GEOTECHNICAL AND GEOLOGIC HAZARD INVESTIGATION
The Ridge Nests Development
Powder Mountain Resort
Weber and Cache Counties, Utah

IGES Project No. 01628-008

July 15, 2016

Subject: Response to Review Comments
Geotechnical Investigation
The Ridge Nests Development
Powder Mountain Resort
Weber and Cache Counties, Utah

FIGURE 1

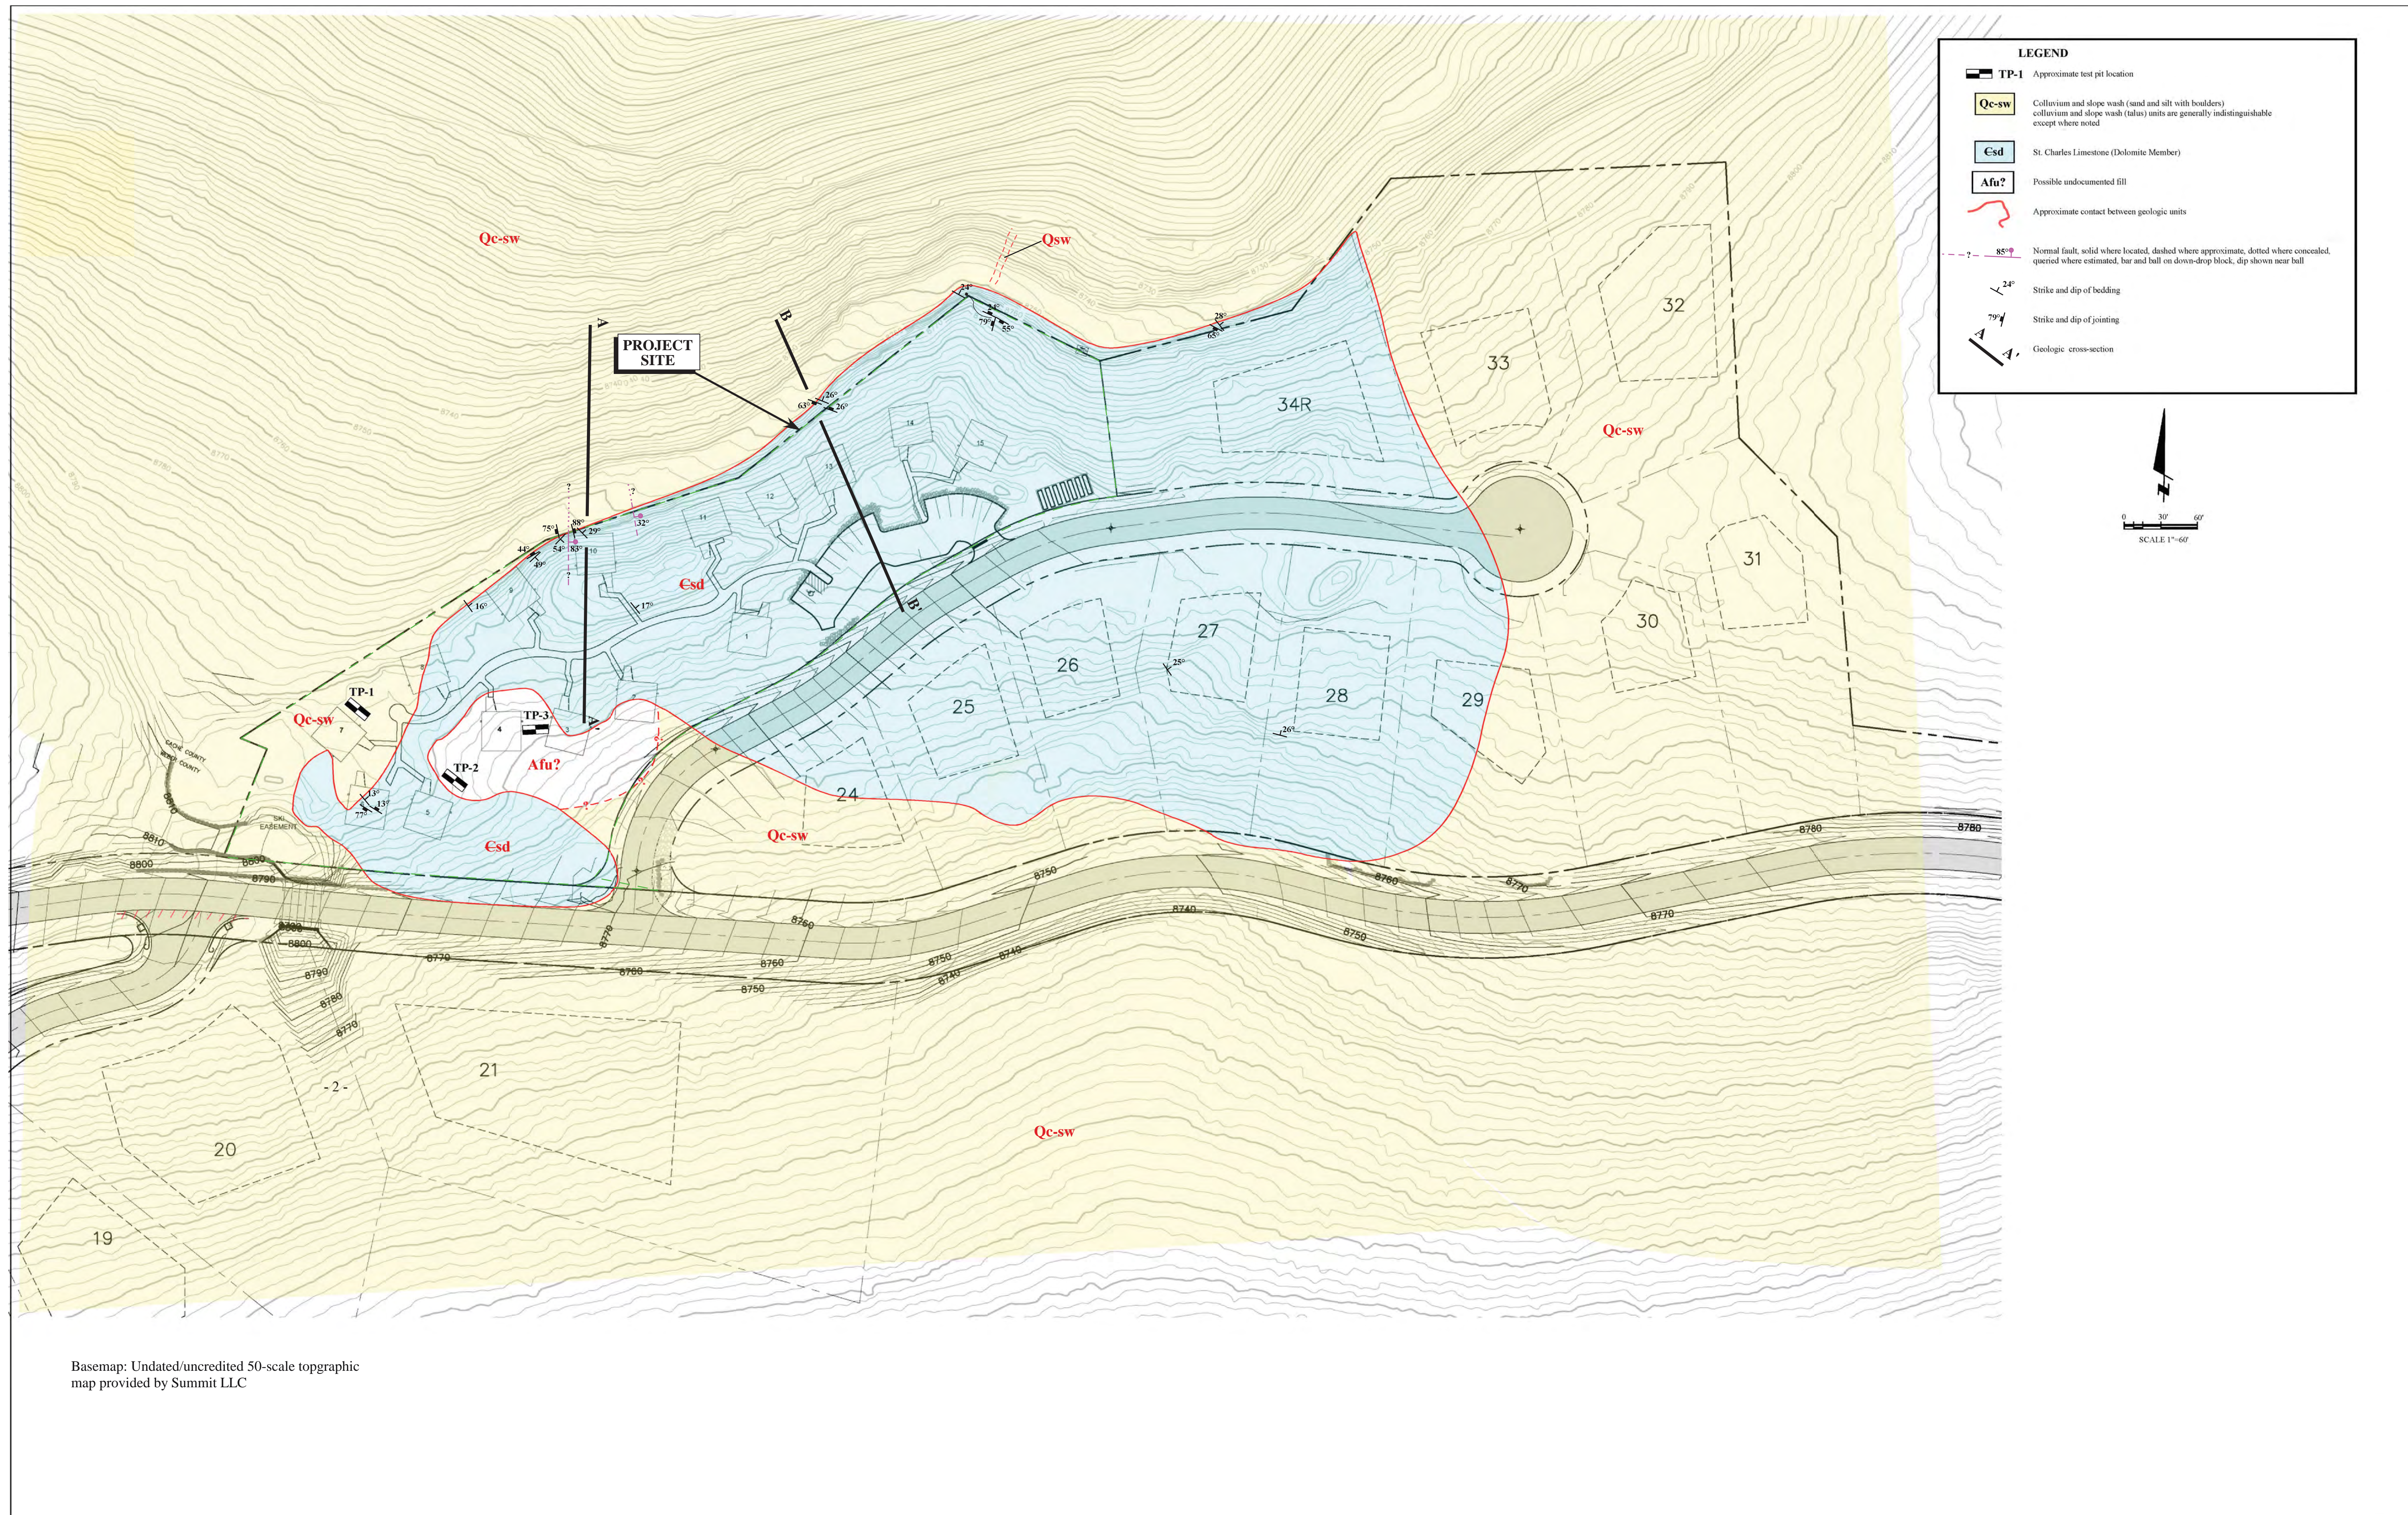
“Figure A-2, Geotechnical Map, of the September 16, 2014 IGES report depicts “...the relative locations of the various geologic units...” described in the September 16, 2014, IGES report. SA recommends Weber County request IGES:

A geologic investigation of Lot 13 and the immediate area surrounding the Ridge Nests subdivision was conducted by an IGES engineering geologist between August 26 and 27, 2015. Plate 1 (*Geologic Map*) is an updated, expanded version of the original Figure A-2, *Geotechnical Map*, from the IGES geotechnical report. The geologic mapping has been extended to several hundred feet in all directions from the original map, and minor modifications to the original geologic contacts have been made based upon the findings of the investigation. Additionally, bedding and jointing attitudes, and the approximate locations and orientations of identified faults are presented on the map. Two geologic cross-sections providing a representative picture of the subsurface of the property are illustrated on Figure 1. A brief description of the findings of the geologic investigation follows.

A semi-continuous exposure of bedrock is present along the southern side of the road that forms the northern boundary for the Ridge Nests property. Along this road, two faults were identified, near the northwest corner of Lot 10 and in between Lots 10 and 11, respectively (see Plate 1 and representative photos on Figure 2). The fault adjacent to the northwest corner of Lot 10 was found to be a subvertical normal fault that juxtaposed Unit 1 and Unit 3, with a minimum of approximately 10 feet of offset (Photo 1). Along the fault trace was a dark red silty material, possibly gouge, that was found linearly along the exposed road cut from the base of the exposed outcrop to just below a large pine tree sitting atop the outcrop (Photo 2). The west side (footwall) of the fault contained bedding that had been tilted in a manner not seen elsewhere on the property, steeply dipping ($>45^\circ$) to the southeast, while the east side (hanging wall) of the fault contained bedding attitudes that were similar to the bedrock elsewhere on the property (dipping between 15 and 25° to the northeast). This fault is considered to be inactive, due to several factors:

Photo 1. Finer-grained dolomite lithology, exhibiting thinner beds and blocky jointing.

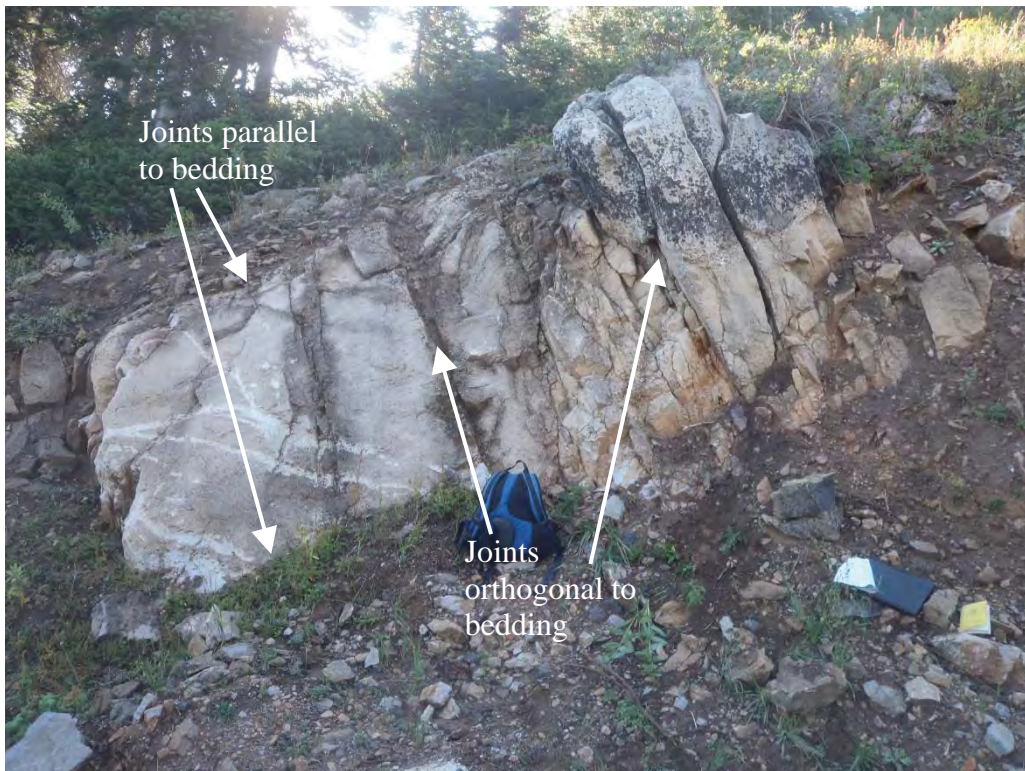
“The September 23, 2015, IGES response letter did not describe the properties of the bedding and/or jointing for incorporation into the slope stability analyses, e.g., properties such as, strike and dip, degree of fracturing (generally controlled by the number of joints in a given direction), persistence of jointing, spacing of jointing, roughness of joint surface, open and/or closed joints, joint coatings and infillings, etc.

Should the Weber County Consulting Geotechnical Engineer consider the properties of bedding, joints, and/or fractures pertinent in regards to slope stability analyses presented in the September 23, 2015 IGES response letter, SA recommends Weber County request documentation of the bedding, joint, and/or fracture properties, and incorporation of the geologic data in the slope stability analyses.”

IGES did describe the strike and dip of the bedding and jointing in the September 23, 2015 response letter; IGES noted bedding near the subject site was oriented (strike) about N24°W and dip (inclination from the horizontal) at 25°NE. The bedrock was found to have blocky jointing, with the two major sets being orthogonal to one another. One joint set was parallel to the bedding, and the other was perpendicular to the bedding, dipping steeply to the southwest. The joint set parallel to the bedding has the same strike and dip orientation as the bedding, while the other major joint set perpendicular to the first has a strike of approximately N24°W and a dip of approximately 65°SW.

In response to the comment, the following additional details are provided: bedrock was found to be largely moderately fractured (distance between fractures ~0.5-1.0 feet) to little fractured (distance between fractures ~1.0-4.0 feet), with localized areas of intense fracturing (distance between fractures ~0.05-0.1 feet). Joint spacing was largely found to be a product of the lithology. The finer-grained dolomite lithologies were more thinly bedded, and therefore had a smaller distance (approximately 1 to 4 inches) between bedding plane joints. These lithologies also tended to fracture into rectangular blocks generally between 4 and 18 inches in length and width, and contained both bedding-confined and through-going fractures (Photo 1). Coarser-grained dolomite lithologies were more thickly bedded to massive, with bedding plane joints separated by between 6 inches to as much as several feet. These lithologies tended to fracture into rectangular blocks with highly variable dimensions, ranging in width and length from between a couple inches to several feet, though larger blocks (with dimensions of several feet x several feet x several feet) were most common (Photo 2). Most fracturing associated with the coarser-grained dolomite lithologies consisted of large through-going fractures.

Nearly all of the joints encountered in the field investigation were open, had slightly rough to rough surfaces, and did not contain a secondary mineralization, except rare calcite infilling in places. No slickensides were observed on any joint surface. Joint apertures varied from between a few millimeters to a couple inches in width. Joints with smaller apertures tended to be devoid of any sort of fill, while the larger aperture joints were often filled with soil. In the cases of the two identified faults, reddish gray silty gouge was found to be the fill material.
